SUITE 501/502 - INVENTORY SUITE

CLIENT: ROYAL PINE HOMES		UNIT 501/502 HMP STD	ROOM:	KITCHEN FLOOR PLAN	DRAWN BY: SK	COMMENTS:	
SITE: HAMPTON PLACE	DOOR STYLE: --	DOOR HANDLE: --	SCALE: 1/2" = 1'-0"	PLEASE NOTE ALL DIMENSIONS ARE NOT FINAL AND ARE SUBJECT TO CHANGE UPON FINAL SITE MEASURE			
PHONE: --	FINISH: --	DRW HANDLE: --	DATE: MAR 7, 2018				
EMAIL: --	SPECIES: --	TOP: --	PAGE: --

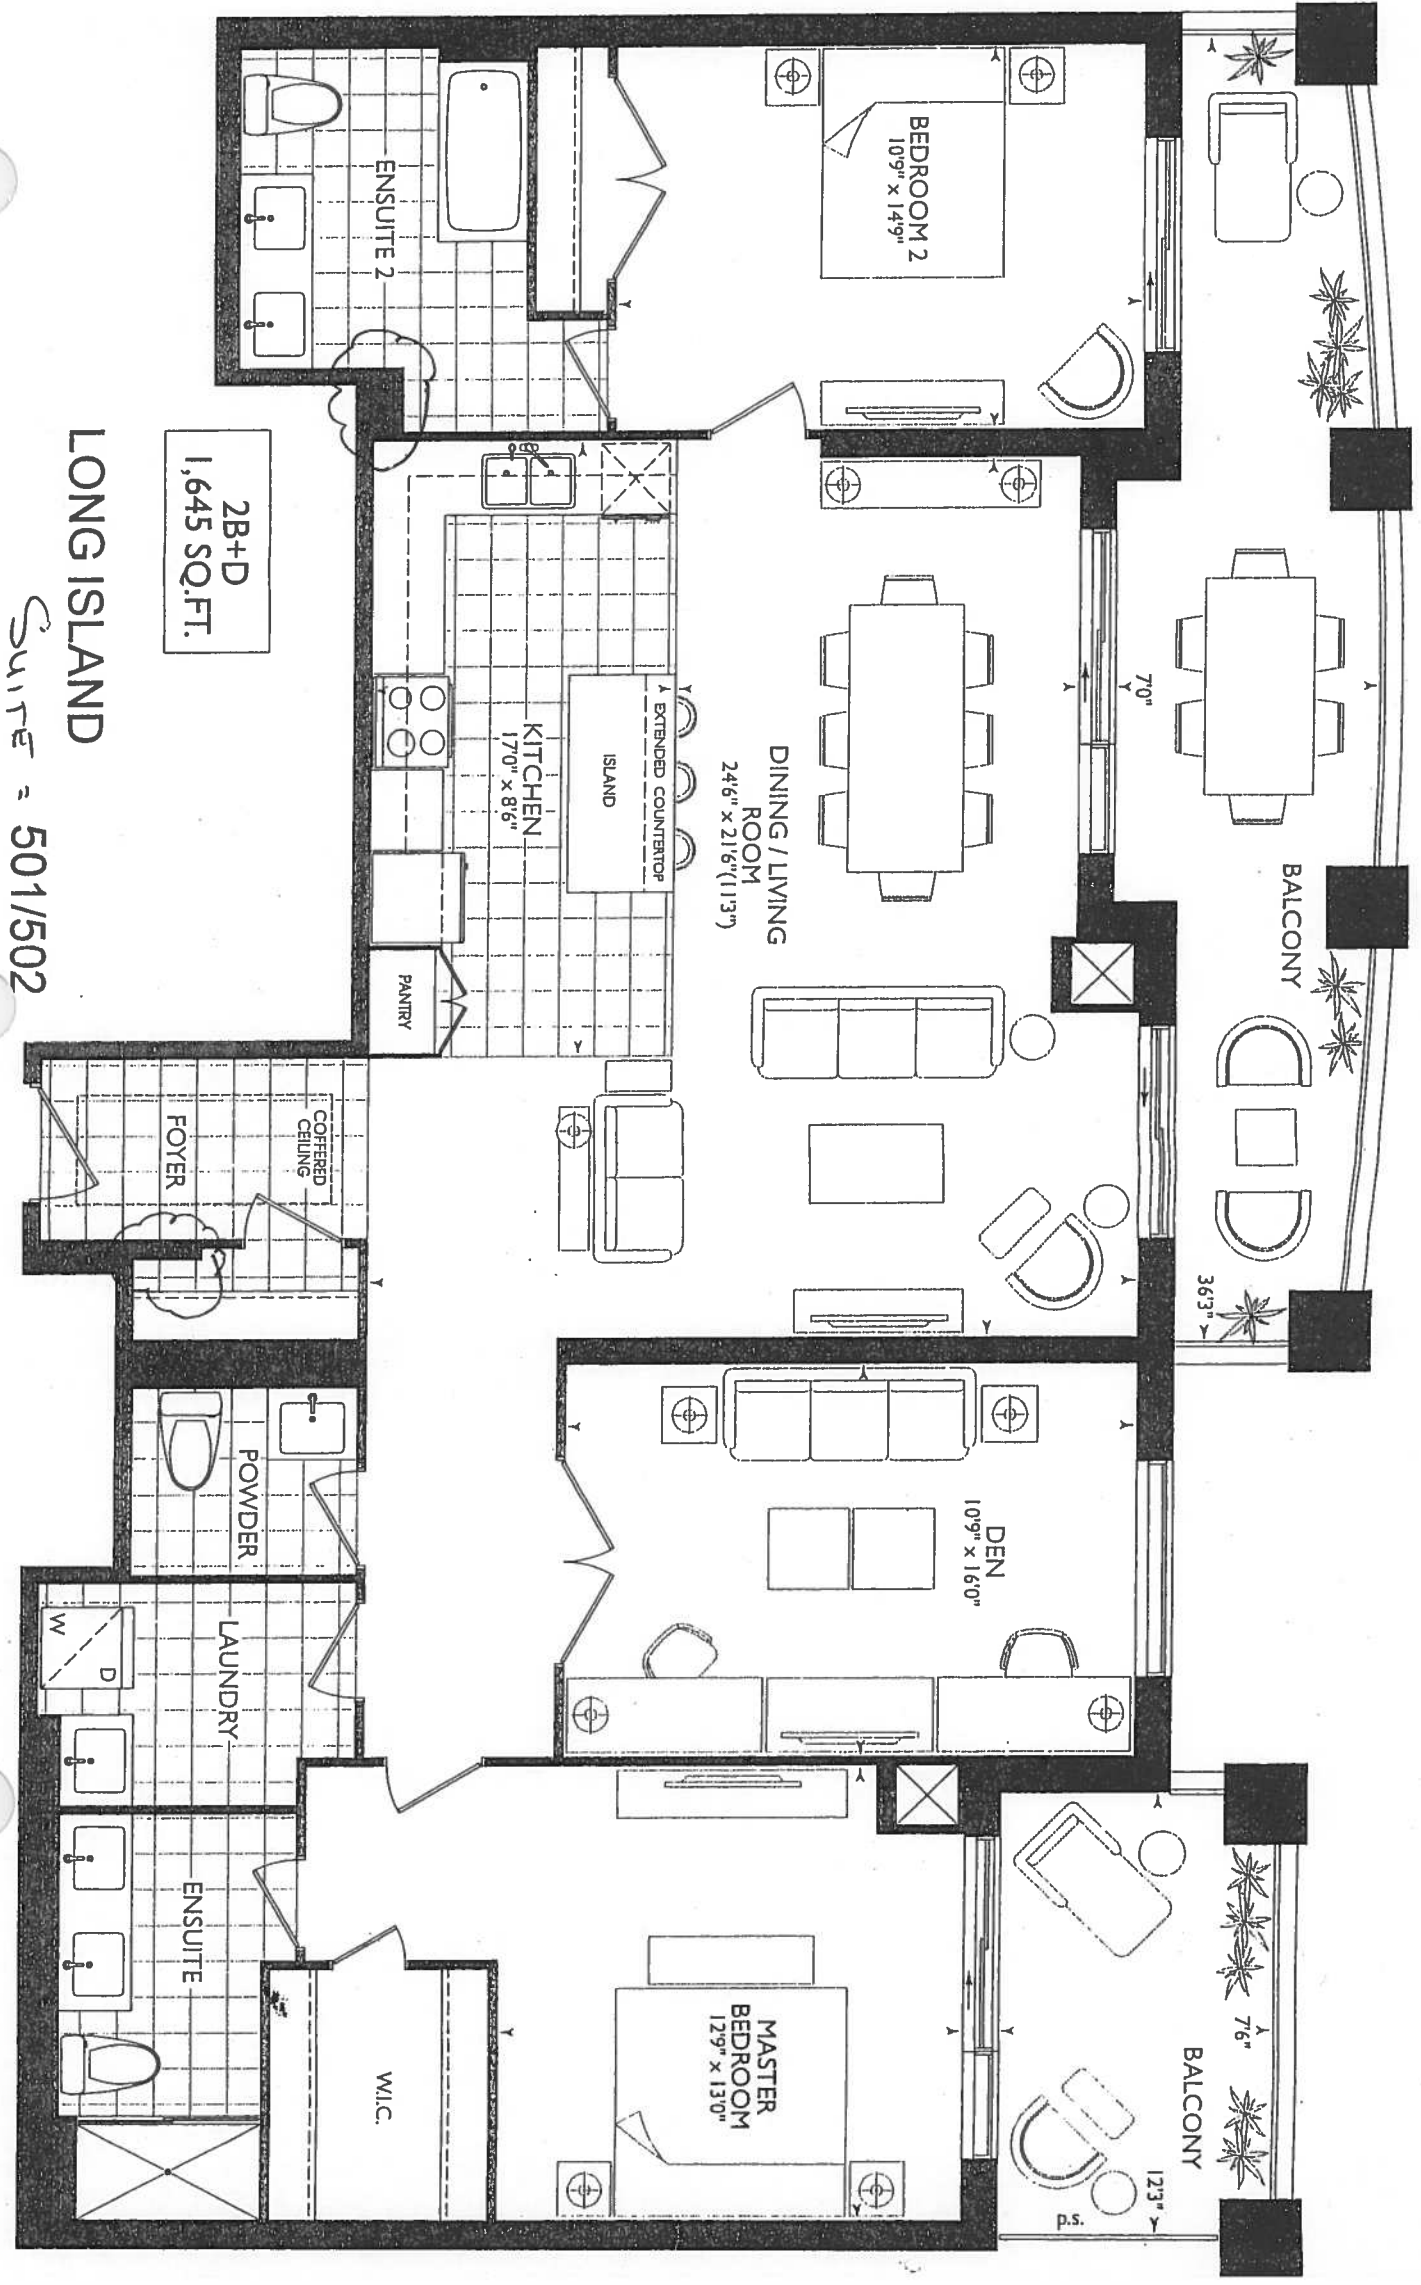
KITCHEN

OSTD KITCHEN LAYOUT

STD APPARANCE PKG.

• $(x^2) = \text{PLUGS}$ ISLAND

- $(x_2) = \text{PENDANT}$

• (x5) Puck Lights

84" stove PIPE

• 58" sink pipe

- OPTIONAL

KITCHEN + Appliance
PVG.

(see upg KIT. layout)

- 2x6 wall BEHIND WASH/DREYER

501/502 - INVENTORY SUITE

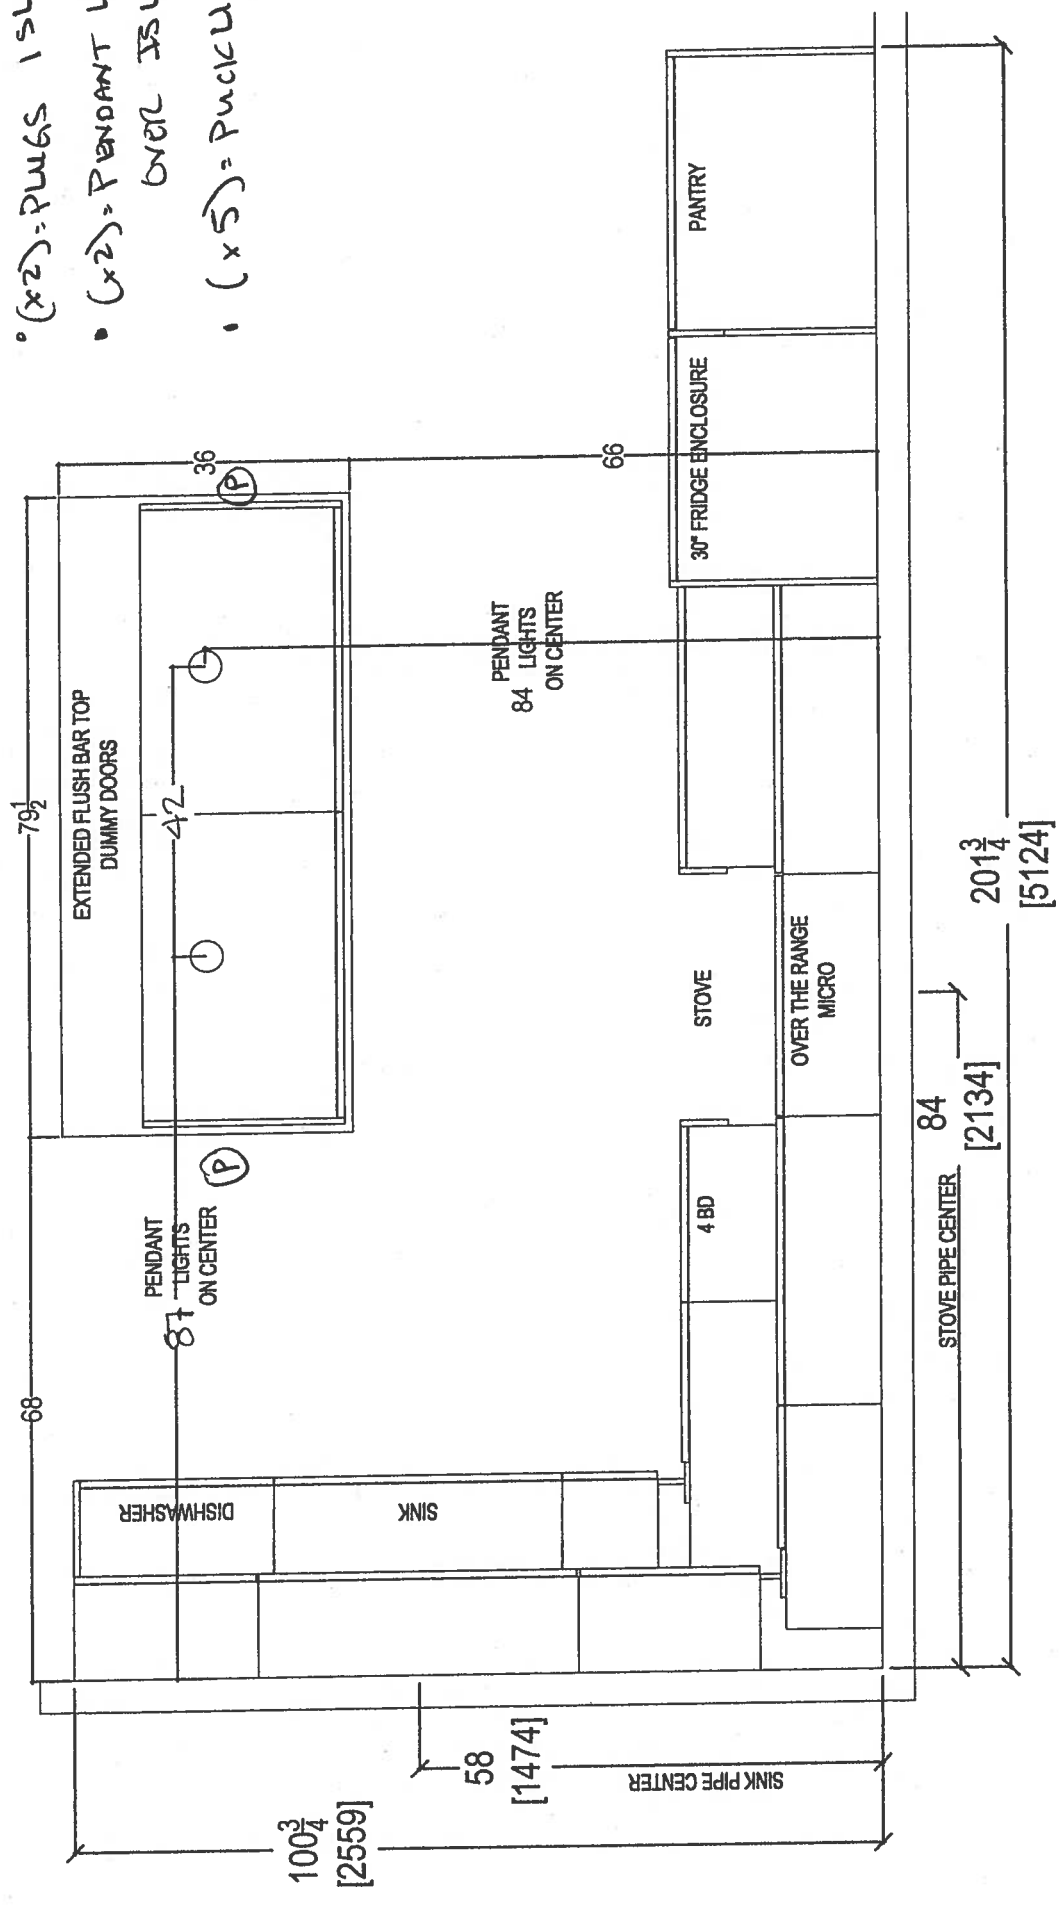
- STD KIT LAYOUT
- STD APPLIANCE PACKAGE
- (x2) - PLUGS ISLAND
- (x2) - PENDANT LIGHTS CAPPED OVER ISLAND
- (x5) - PUCK LIGHTS

501/502 Inventory Suite

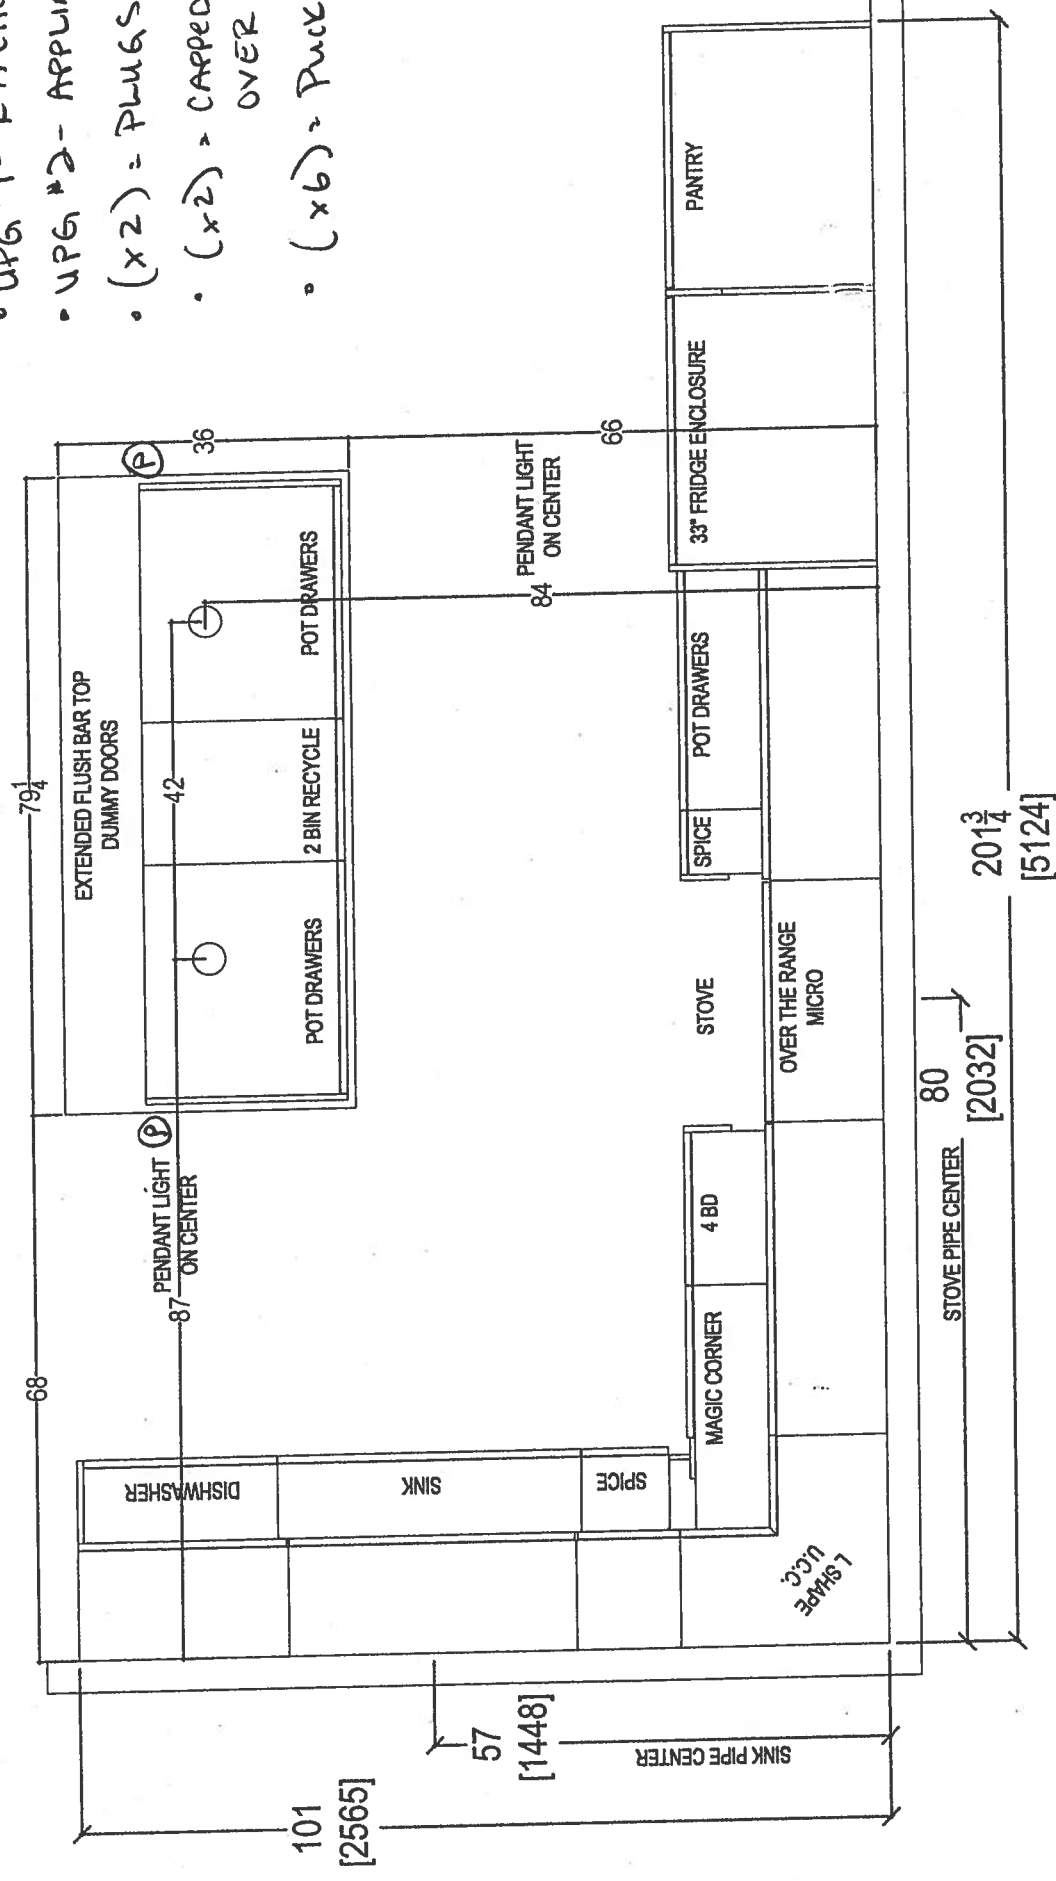
- UPG #1 - KITCHEN LAYOUT
- UPG #2 - APPLIANCE PKGS.
- (x2) = PLUGS ISLAND
- (x2) = CAPPED PENDANT LIGHTS OVER ISLAND
- (x6) = PUCK LIGHTS
